**TYPE III – MODIFICATION  
STAFF REPORT AND RECOMMENDATION**

Revised August 15, 2017

**FILE NO.:** MD 17-01, MD 17-02, MD 17-03, MD 17-04, MD 17-05, and MD 17-06:  
Historic Review for the designs of six (6) cottage style homes in the Canemah  
Historic District.

**REQUEST:** The applicant is requesting design approval for the construction of six (6) new  
construction cottage style dwelling units, with preservation incentives to  
adjustment the front, side, and rear setbacks, in the Canemah Historic  
District.

① House #1 South  
1/4" = 1'-0"

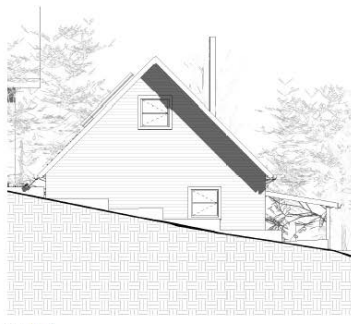
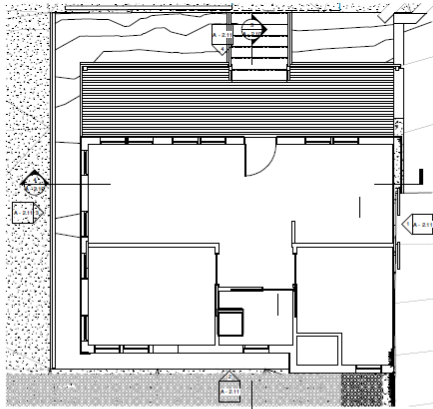
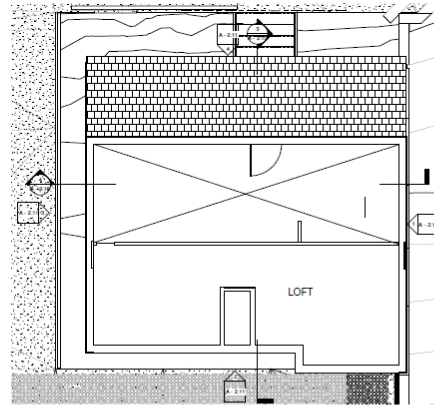
In the design of home number one, the applicant has indicated that they are planning to remove a significant portion of the abutting topography, creating a cutout for the home and a twelve (12) foot wide driveway on the existing lot. This home will also be located directly upon the east property line.

The proposed landscaping in front of the front of the home is unclear. The applicant will need to go through Geotechnical Review along with Site Plan and Design Review.

- a. Retaining and structural walls shall be minimized; to be faced or finished in stone, mortared basalt, or concrete, and not exceed 3 ½ feet, to complement the Canemah Neighborhood.
- b. Concrete foundations shall have a natural, parged or painted finish.
- c. Exposed foundations shall be site screened with vegetation if concrete or masonry exceeds 3½ feet, or if pilings or posts are 1½ feet above grade.
- d. A minimum of 5 shrubs and groundcover shall be installed along the façade of the front porch.
- e. Roofing shall use traditional materials such as wood shingles, composition, and metal shingles.
- f. Skylights shall be installed in inconspicuous roof slopes and skylights shall be mounted close to the roof plane, and not visible from the right-of-way.

① House #2 West  
1/4" = 1'-0"

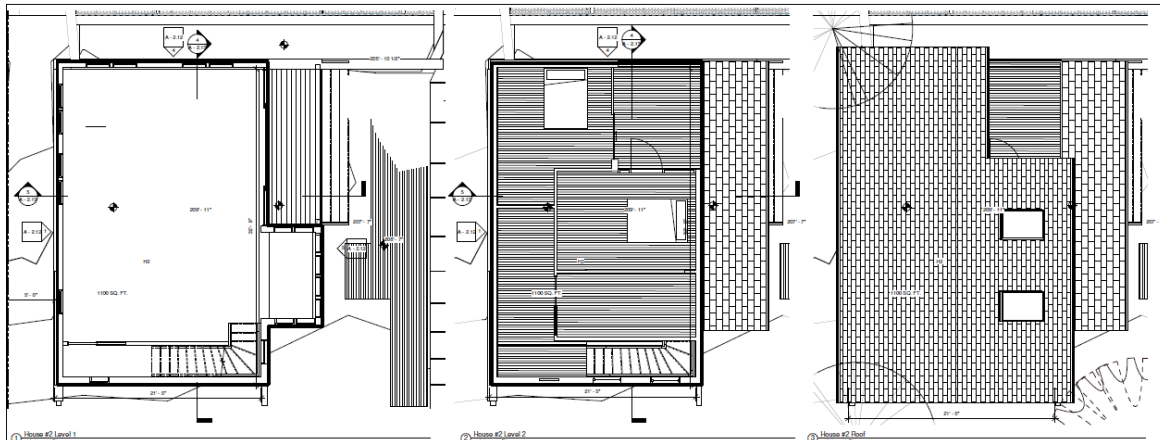
**Finding: Complies with Condition.** House two (2) is located approximately 40 feet south of house one (1) on the site plan, and appears to be designed as an 1100 square foot 1 ½ story modern Vernacular home completely sided in horizontal shiplap. The deck on east side of the house is with a flat, slightly elevated, with no front railing. The east side of the first story is has four large full light windows, creating a French door like entrance. To the south of the main entrance is a small bump out from the main building on which there are four small square double hung windows. To the south of the bump out is one large rectangular double hung window. The east facing deck is also covered by overhanging eave. On the second story of the east side there is a portion of the roof that has been removed to make space for a second story outdoor seating area. The entrance leading to this outdoor seating area is composed of two full light glass doors with two large square windows above the glass doors on the east side of the cutout and one full light glass door surrounded by window on south side of the cutout. The outdoor seating area is bordered on the east and west sides by a railing with thin spindles and a top rail. On north side of the first story there are four large rectangular double hung windows and one large rectangular double hung window on the second story.

The first story on the south side of the house contains one small square double hung window with a concrete planter box along the foundation of the building. The side of the east-facing bump out is visible on the south side of the house; there are two small square double hung windows visible on the side of said bump out. On the second story of the south side of the home, a series of stepped windows are used. A large double hung rectangular window is illustrated to be near the top of the structure, stepping down to two small double hung square windows.

- a. Residential doors shall complement the design and detailing of the historic style with similar appearance to wood. Doors shall be designed in a stile and rail type; panel design; with upper portion glass. The primary door may be a solid panel door.
- b. Gable roof slopes shall have equal pitch. Gable primary roofs shall have a pitch of 8:12 or greater (6:12 for Bungalow). Porch or bay roofs may have lower slope, may have hip if style allows. Roofs shall have a minimum 1 foot overhang with a maximum of 3 feet.
- c. Windows shall match the member sizing, thickness and shadowline of painted wood windows. Windows shall also consist of the following designs: double, single hung, or casement. Wood clad shall be matching in color and finish. Non-wood fiberglass and aluminum windows are acceptable if in appropriate style, and matching wood in profile, shadowline, and if similar in

- d. Concrete foundations shall have a natural, parged or painted finish.
- e. Exposed foundations shall be site screened with vegetation if concrete or masonry exceeds 3½ feet, or if pilings or posts are 1½ feet above grade.
- f. Roofing shall use traditional materials such as wood shingles, composition, and metal shingles.
- g. Skylights shall be installed in inconspicuous roof slopes and skylights shall be mounted close to the roof plane, and not visible from the right-of-way.

① House #3 South  
1/4" = 1'-0"

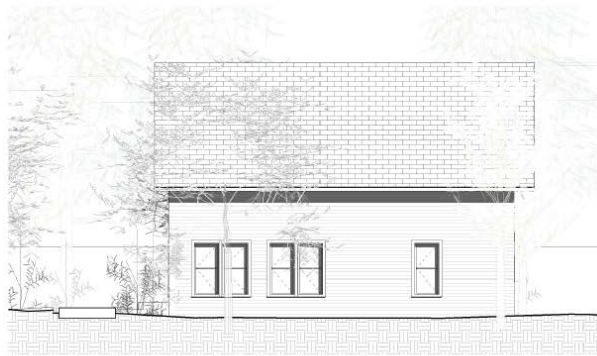
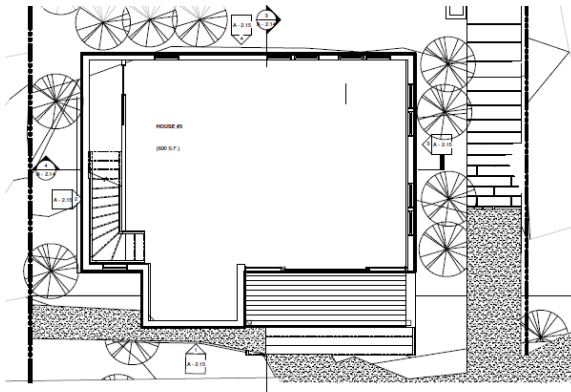
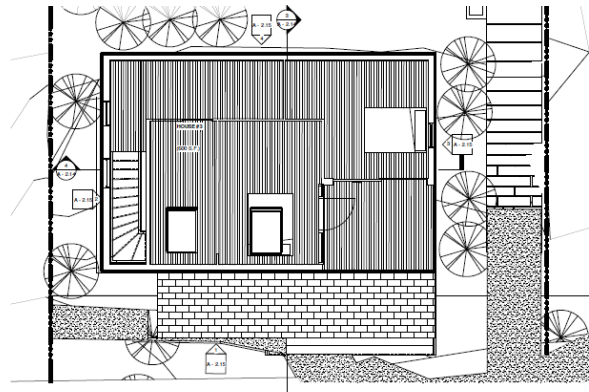
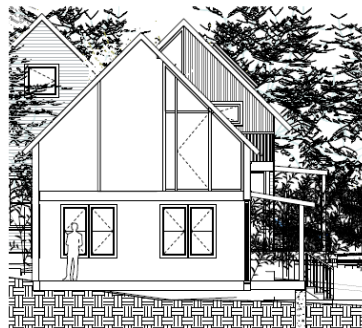
- Roofing shall use traditional materials such as wood shingles, composition, and metal shingles.
- Skylights shall be installed in inconspicuous roof slopes and skylights shall be mounted close to the roof plane, and not visible from the right-of-way.

- a. Primary residential doors shall complement the design and detailing of the historic style with similar appearance to wood. Doors shall be designed in a stile and rail type; panel design; with upper portion glass. The primary door may be a solid panel door. Sliding doors are not permitted.

- b. Gable roof slopes shall have equal pitch. Gable primary roofs shall have a pitch of 8:12 or greater (6:12 for Bungalow). Porch or bay roofs may have lower slope, may have hip if style allows. Roofs shall have a minimum 1 foot overhang with a maximum of 3 feet.

- c. Windows shall match the member sizing, thickness and shadowline of painted wood windows. Windows shall also consist of the following designs: double, single hung, or casement. Wood clad shall be matching in color and finish. Non-wood fiberglass and aluminum windows are acceptable if in appropriate style, and matching wood in profile, shadowline, and if similar in color and finish. If a non-wood style is proposed, a sample is required to be approved by the Historic Review Board.

## Proposed House 4:

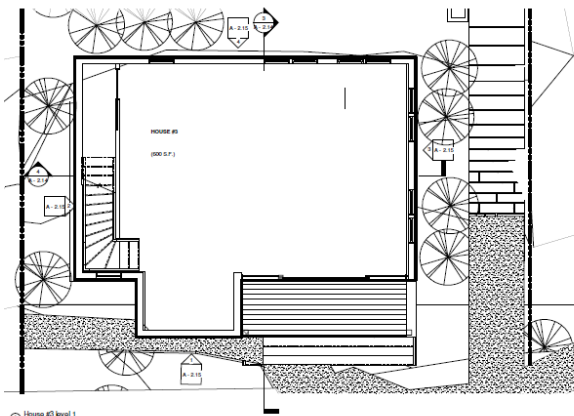
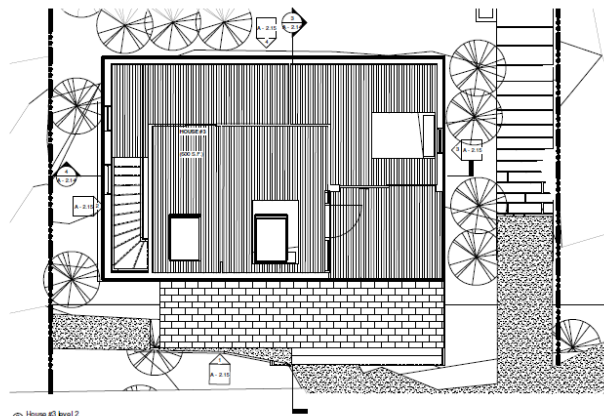
- Roofing shall use traditional materials such as wood shingles, composition, and metal shingles.
- Skylights shall be installed in inconspicuous roof slopes and skylights shall be mounted close to the roof plane, and not visible from the right-of-way.

- a. The main entrance of the house shall not be oriented towards the adjacent parking lot.
- b. Windows shall match the member sizing, thickness and shadowline of painted wood windows. Windows shall also consist of the following designs: double, single hung, or casement. Wood clad shall be matching in color and finish. Non-wood fiberglass and aluminum windows are acceptable if in appropriate style, and matching wood in profile, shadowline, and if similar in color and finish. If a non-wood style is proposed, a sample is required to be approved by the Historic Review Board.

- c. Residential doors shall complement the design and detailing of the historic style with similar appearance to wood. Doors shall be designed in a stile and rail type; panel design; with upper portion glass. The primary door may be a solid panel door. Sliding doors are not permitted on any portion of the house.

## House 6:

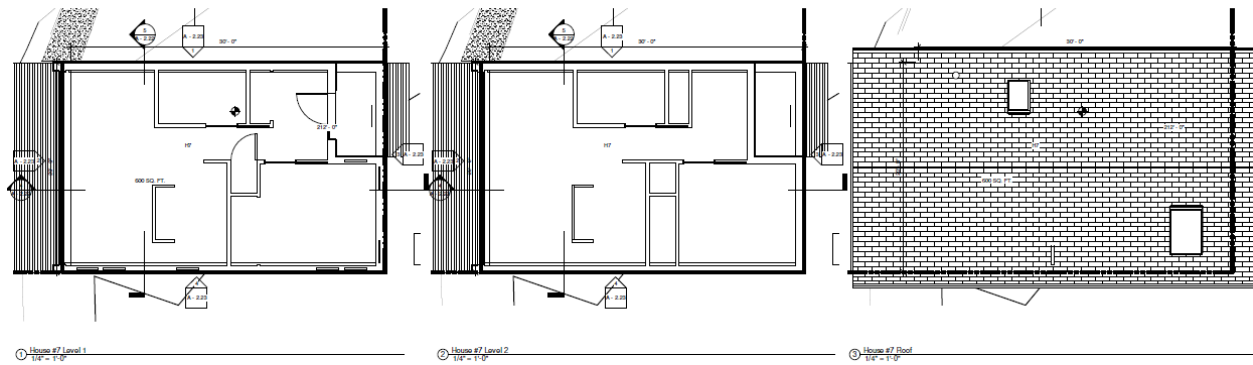
- Roofing shall use traditional materials such as wood shingles, composition, and metal shingles.
- Skylights shall be installed in inconspicuous roof slopes and skylights shall be mounted close to the roof plane, and not visible from the right-of-way.

- a. Residential doors shall complement the design and detailing of the historic style with similar appearance to wood. Doors shall be designed in a stile and rail type; panel design; with upper portion glass. The primary door may be a solid panel door. Sliding doors are not permitted on any portion of the house.

- b. Windows shall match the member sizing, thickness and shadowline of painted wood windows. Windows shall also consist of the following designs: double, single hung, or casement. Wood clad shall be matching in color and finish. Non-wood fiberglass and aluminum windows are acceptable if in appropriate style, and matching wood in profile, shadowline, and if similar in color and finish. If a non-wood style is proposed, a sample is required to be approved by the Historic Review Board.

- c. Gable roof slopes shall have equal pitch. Gable primary roofs shall have a pitch of 8:12 or greater (6:12 for Bungalow). Porch or bay roofs may have lower slope, may have hip if style allows. Roofs shall have a minimum 1 foot overhang with a maximum of 3 feet.
